STATE OF NEW MEXICO
ENERGY AND MINERALS DEPARTMENT

Re: Application for Non-Standard
Location: Unit C, Sec. 18,
T-29-N, R-14-W, San Juan County,
New Mexico

This letter is a request for the approval of an unorthodox drilling location to be positioned, (please find survey plat enclosed) at Unit Letter C, Section 18, Township 29 North, Range 14 West, San Juan, New Mexico. The actual footage of the well is: 1310' FNL and 1740' FWL with a ground level elevation @ 5141; the reason for this request is that the northern portion of the proration unit is a portion of the Unincorporated Townsite of Kirtland, and the southern portion has another operator. Suburban Propane operates the south (please see plat) and our company, Caribou Four Corners, Inc. operates to the north.

STATE OF NEW MEXICO
OIL AND MINERALS DEPARTMENTP. O. BOX 2088
SANTA FE, NEW MEXICO 87501Form C-107
Revised 10-1-78

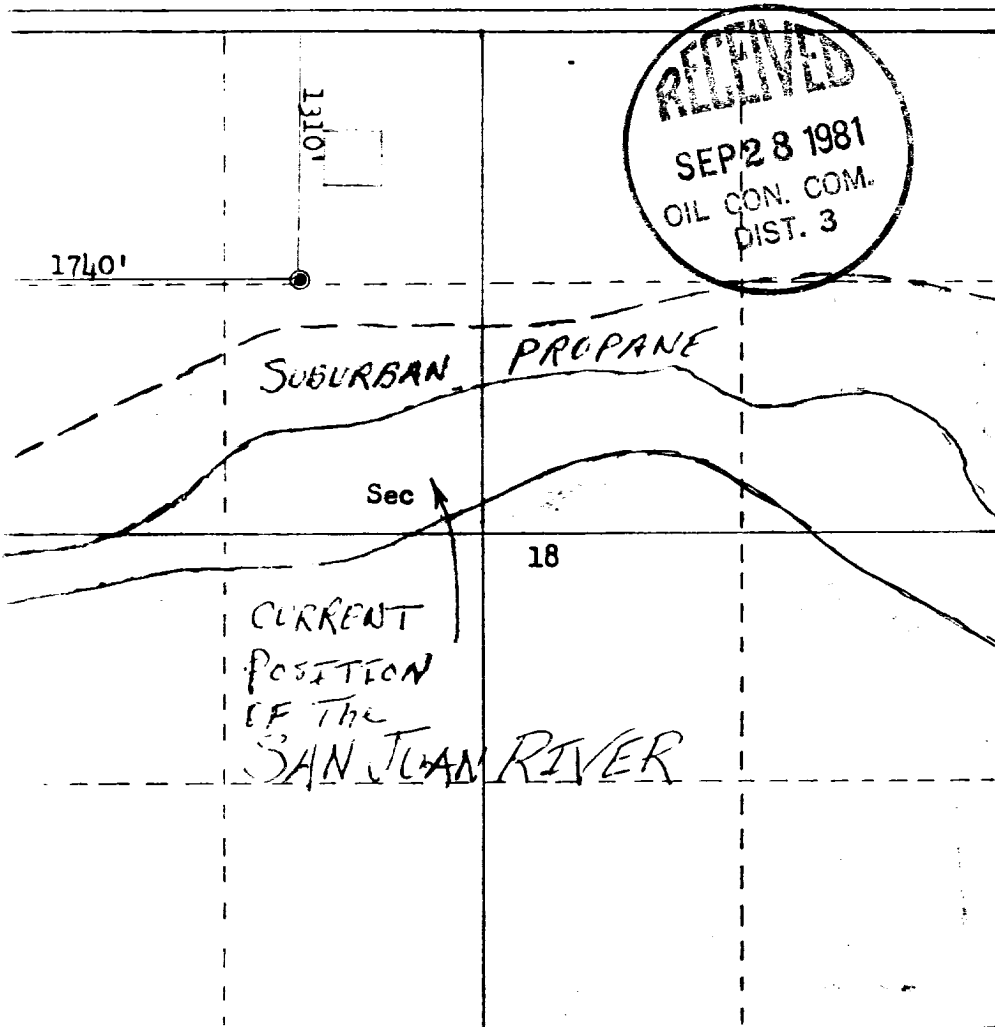
☒ A plat must be submitted clearly showing the ownership of the offsetting leases.

☒ A plat must be submitted fully identifying the topography necessitating the non-standard location.

The above plat is of the E $\frac{1}{2}$, NW $\frac{1}{4}$, Sec. 18 T29N, R14W, San Juan. Showing the offset owners. It will be noted that the northern $\frac{1}{2}$ of the NW $\frac{1}{4}$ is all residential area, which necessitates the request for the non-standard location, which is 1310' FNL, 1740' FILL.

Scale 1" = 400'

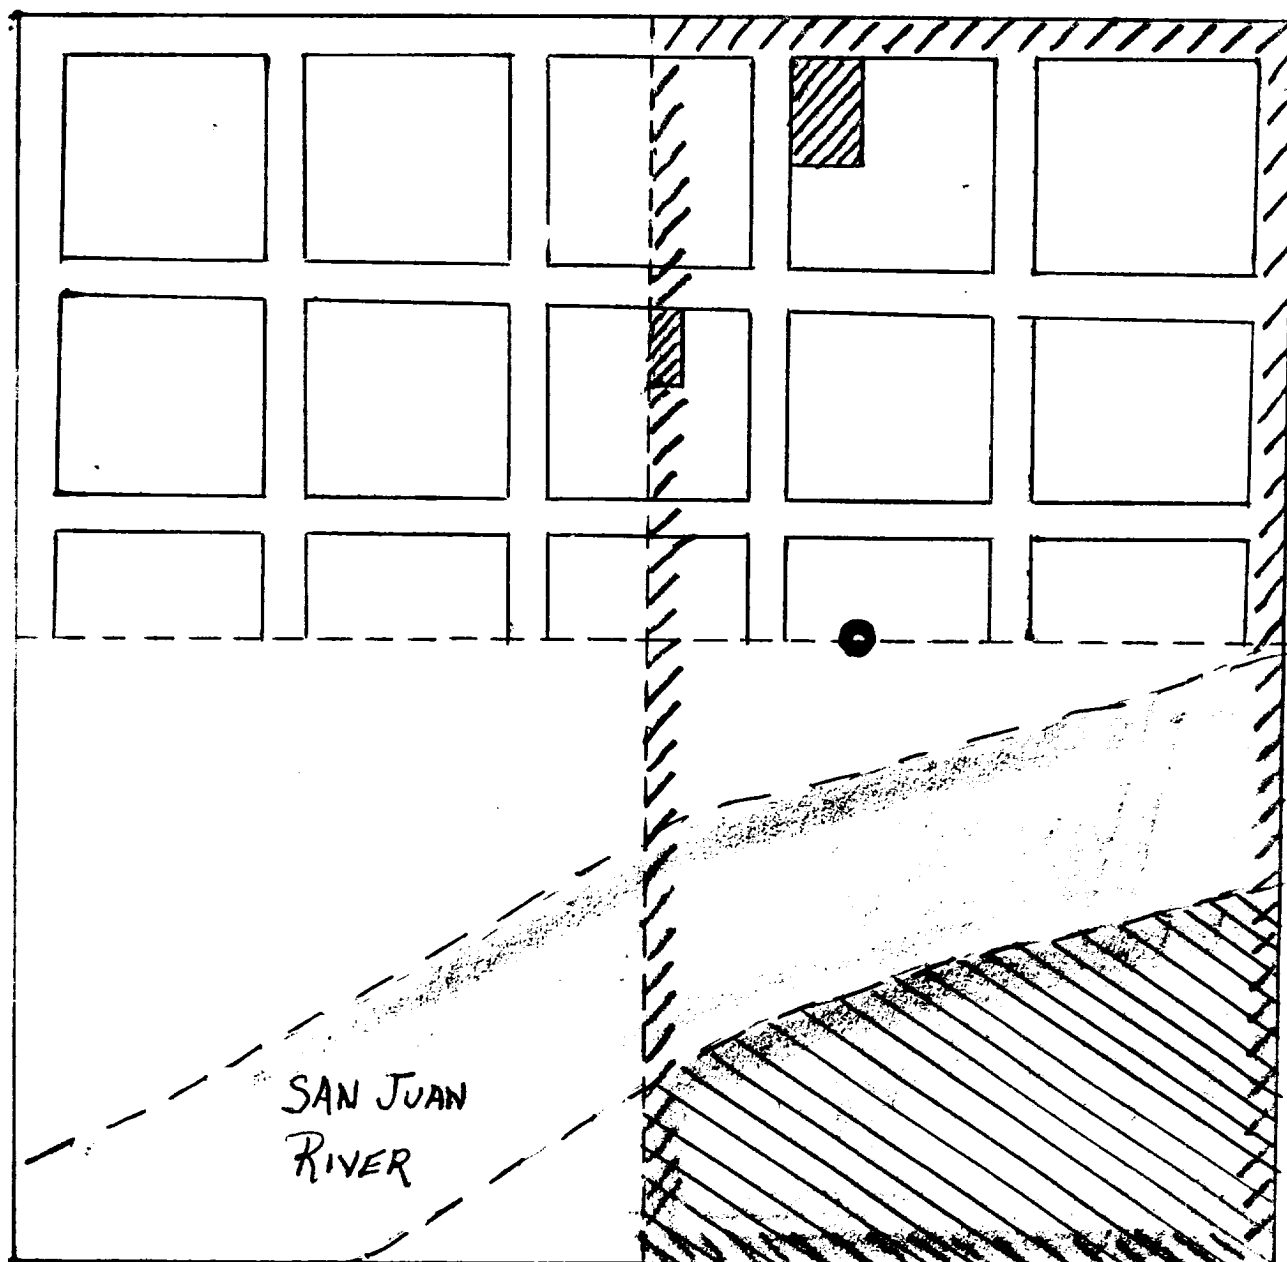
☒ A statement must be submitted that offset owners have been notified of the application by certified mail.
